## SLG46620-EV Errata Note

This document contains the known errata for SLG46620-EV and the recommended workarounds.

### 3.2 ACMP Output Glitch due to Ring OSC Operation

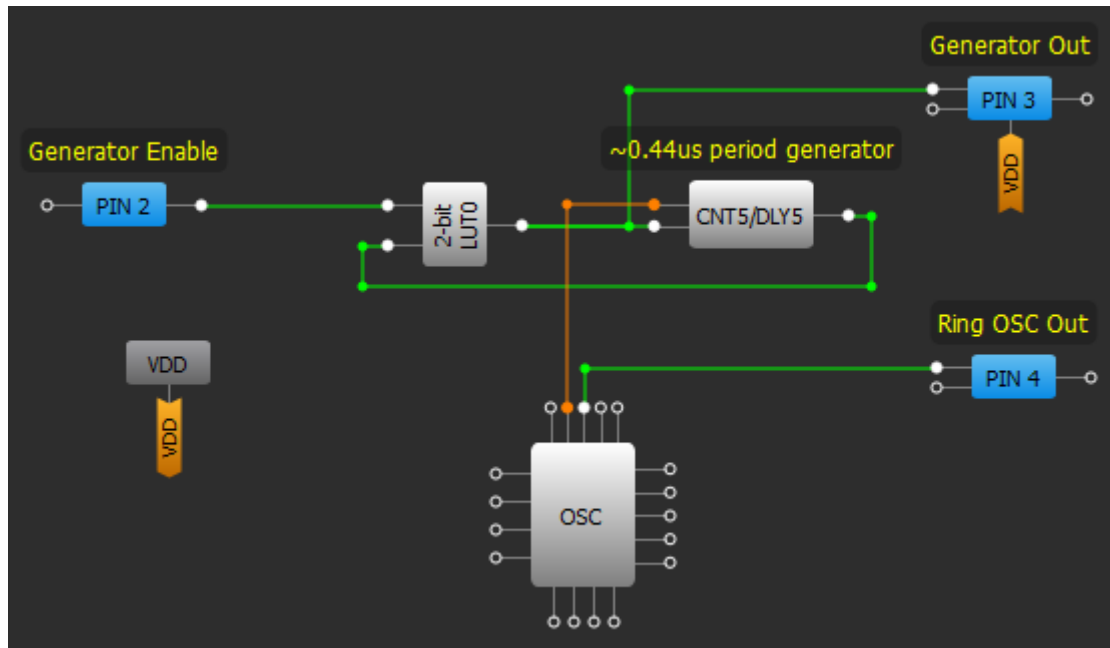
The output of the ACMP incorrectly goes low even when IN+ is greater than IN- if the RING OSC is active when the WS signal rises.

Channel 1 – ACMP out

Channel 2 – WS\_OUT

Avoid using the RING OSC with the WS Controller, or add a filtering block on the ACMP output to filter out the glitch.

### 3.3 Long Ring OSC Settling Time

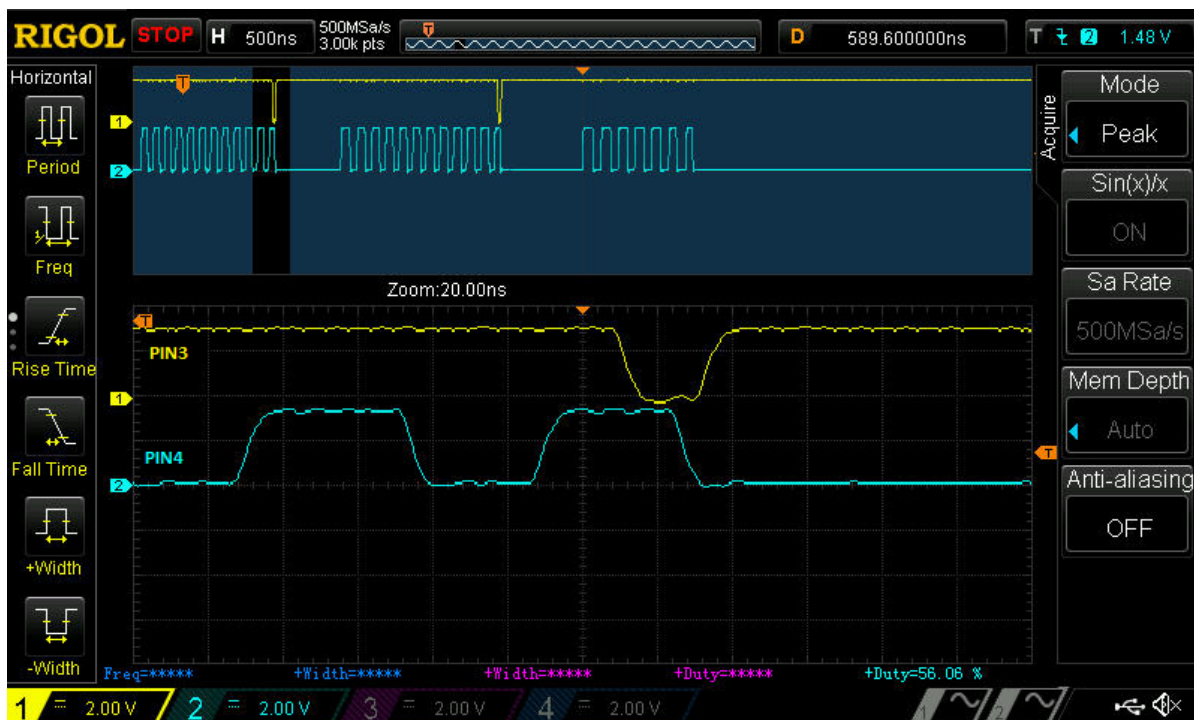
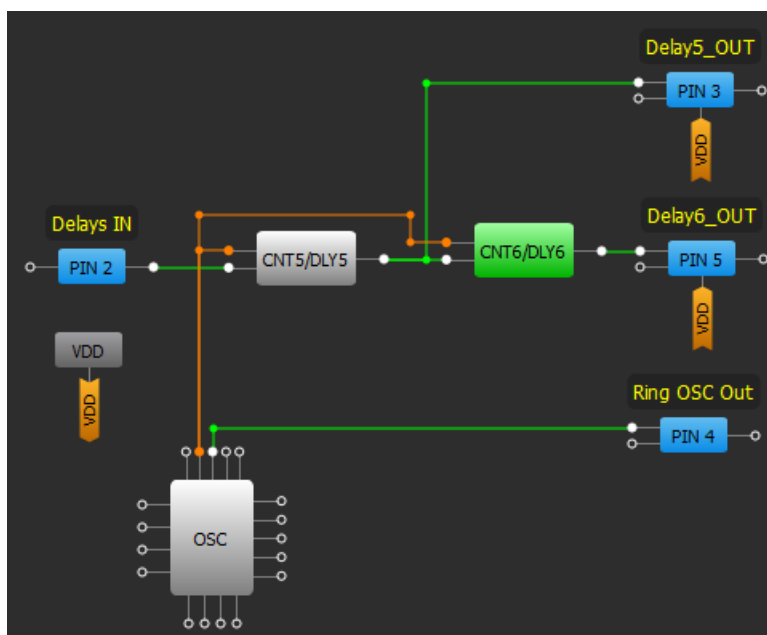
The Ring OSC has a longer settling time when configured as Auto Power On in the designs that have very short Ring OSC disable time. An example of this issue is shown in the following configuration:

The configuration shown above generates a periodical signal with a frequency defined by the Delay cell and started by a high signal on PIN2. The issue becomes apparent in a longer settling time when the scheme generates short pulses (Delay is configured as a rising edge delay only). See waveform below.

Channel 1 – 2-bit LUT0 output; Channel 2 – Ring OSC output

Such behavior will lead to substantial error in period calculations if the delay time is relatively small.

A similar situation can occur while using two connected delays (all edge detect types except for a pair “Rising edge DLY – Falling edge DLY”).

In the following example, Delay5 and Delay6 are configured in the same way. However, Delay5 time is 11.4us instead of expected 0.4us (Delay5 time).

- Set Ring OSC power mode to “Force Power On”
- or, Set Turn on by register option in BG (Band Gap) block as “Enable”

## 3.4 PGA has an Offset when Loaded

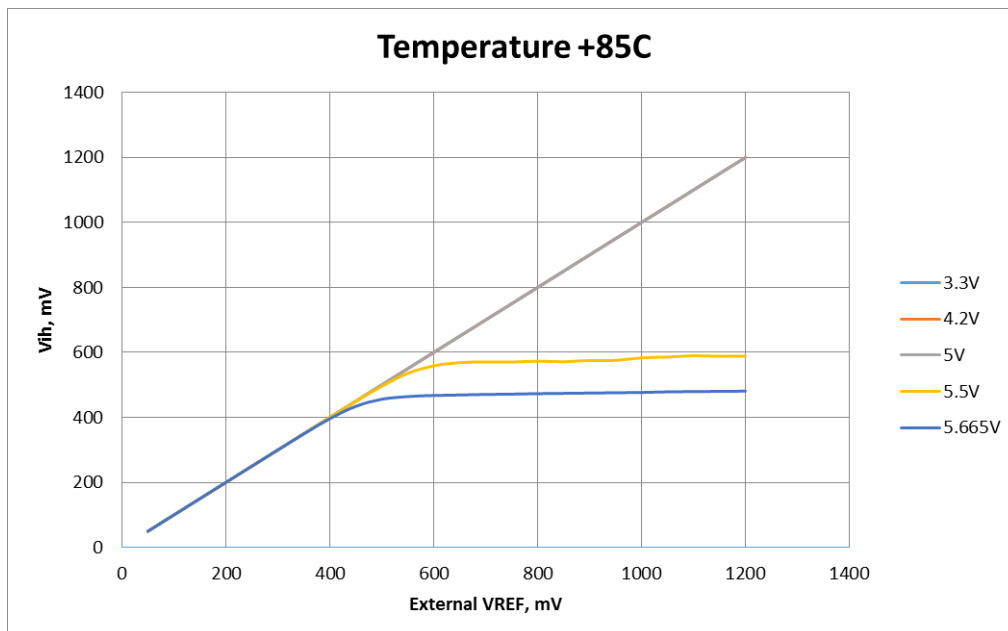
The PGA block has an offset when its output through the VREF is loaded. For reference, the table below shows the load vs PGA 4x gain.

When the load current is higher than 10 mA the output offset is large and may influence the design operation significantly.

Use an external buffer to support high load.

## 3.5 ACMP Output is Inaccurate when Using External Vref at High VDD and Temperature

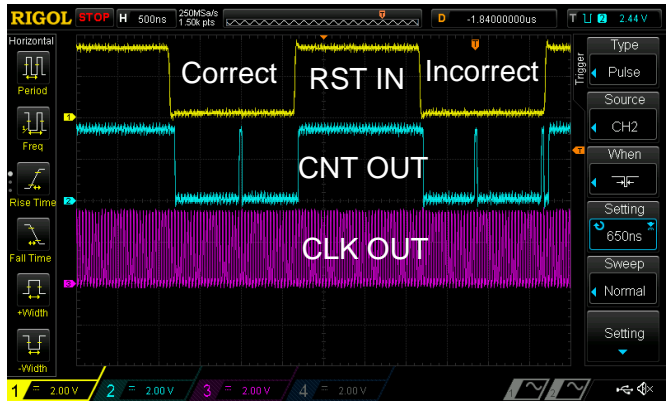
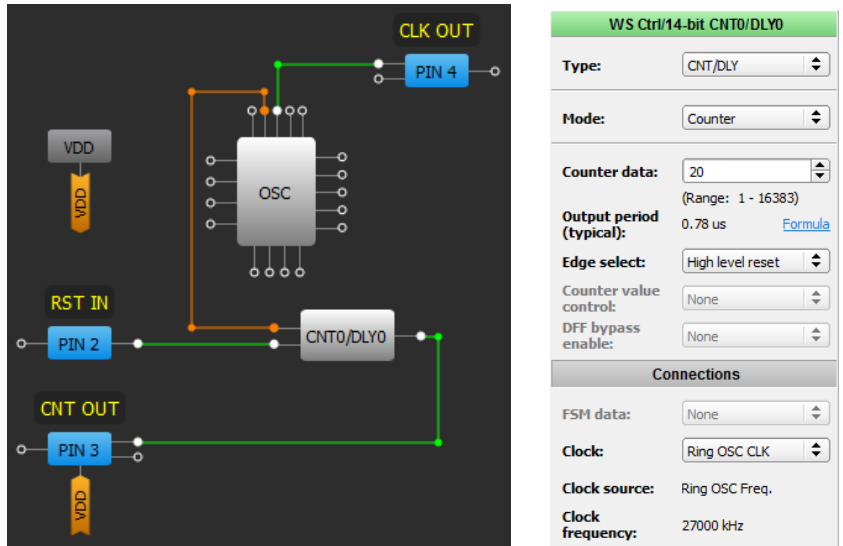
When using external Vref source, the ACMP comparison may happen at wrong threshold if the external Vref voltage is higher than a particular value (please see figure below) at high VDD values (> 5V) and high temperature.

Avoid using ACMPs in such conditions.

## 3.6 Incorrect Counter Operation after the Reset

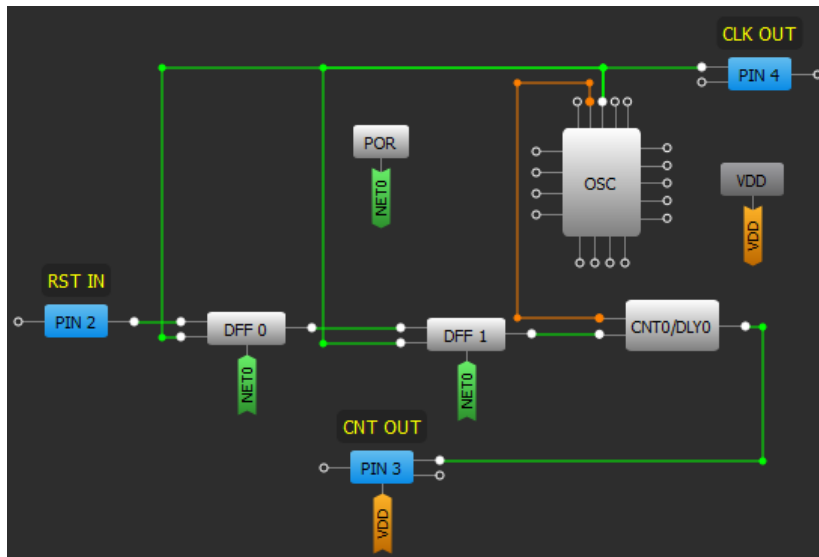
If the Counter Reset occurs at a time very close to a rising edge of the clock signal during clock signal generation (for example OSC operation), there is a possibility that the Counter Data of the Counter is reset incorrectly and the counter end signal (HIGH pulse) may appear faster than expected. This phenomena appears more frequently the higher the clock frequency is.

Synchronize RESET input of the Counter with its CLK using 2 DFF cells as shown in the image below.

### 3.7 DCMP OUT+ Output Glitch

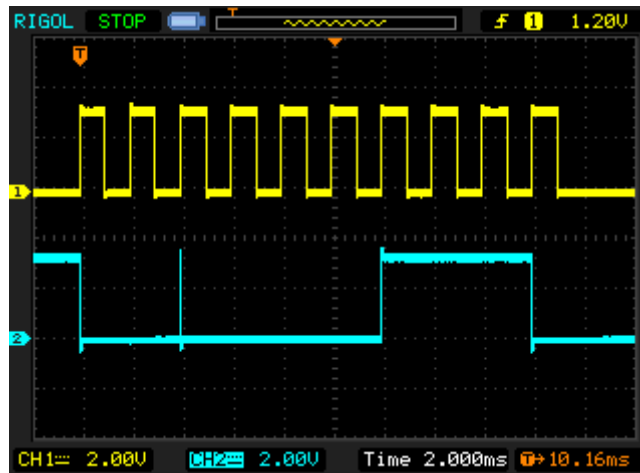
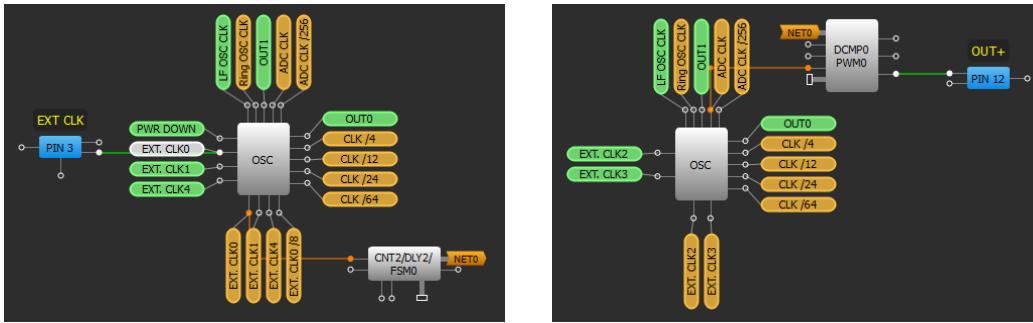
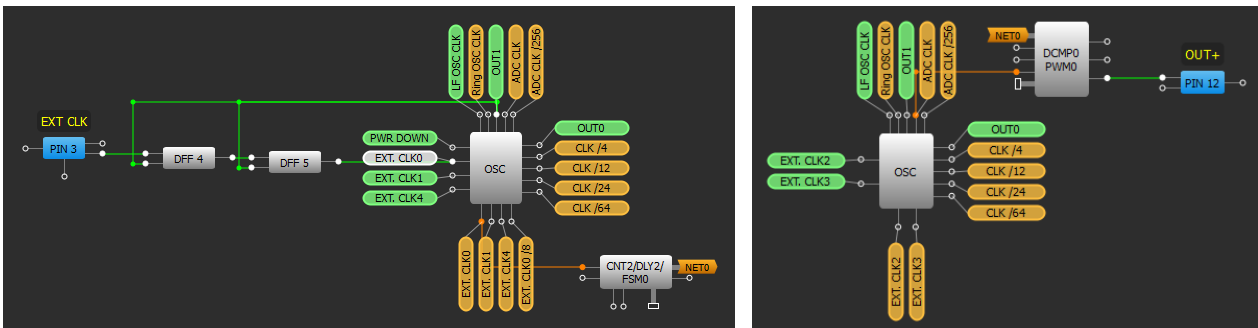
DCMP's OUT+ output may have a glitch when the input data is changed. This issue appears more frequently the higher DCMP clock is.

For example, DCMP IN+ sources from FSM0 and IN- from Register0. DCMP is clocked from the Ring OSC.

Synchronize the data source clock with the DCMP clock source using 2 DFF cells as shown in the images below.
